CHANGE ORDER

PROJECT:
Willie Melton Paving and Drainage Improvements

CHANGE ORDER NUMBER 02
DATE 01/05/2018
PROJECT NUMBER 13115
CONTRACT FOR 828,014.00
CONTRACT DATE 7/11/2017
FBC PURCHASE ORDER NO 154483

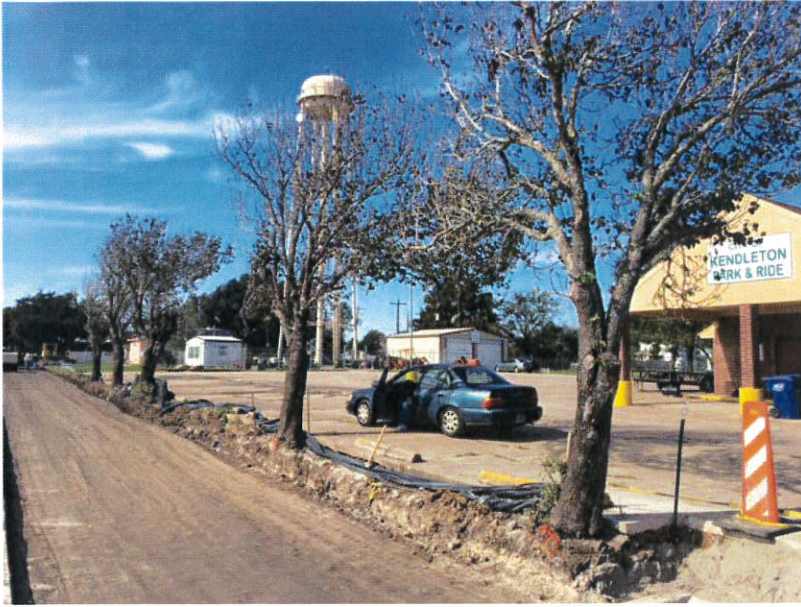
There are 6 trees right at back of curb on Willie Melton (pictures attached). The plans do not show to remove these trees and cost is not in the bid. We can pave the road without removing them but can't stabilize the 1' area behind curb. We are ready to pave this section right after Thanksgiving and need to know what to do at this location as soon as possible.

Conrad Construction sent the attached photos of the trees located in front of the Park & Ride. Does the City want these trees removed? Please let me know soon as it will delay a concrete pour they have scheduled for Wednesday.

As discussed, please proceed to remove the trees for \$ 750 per tree for a total amount of \$ 4,500.00.

I just spoke with the Mayor and he confirmed that the trees can be removed. Please submit pricing to the construction manager for review.
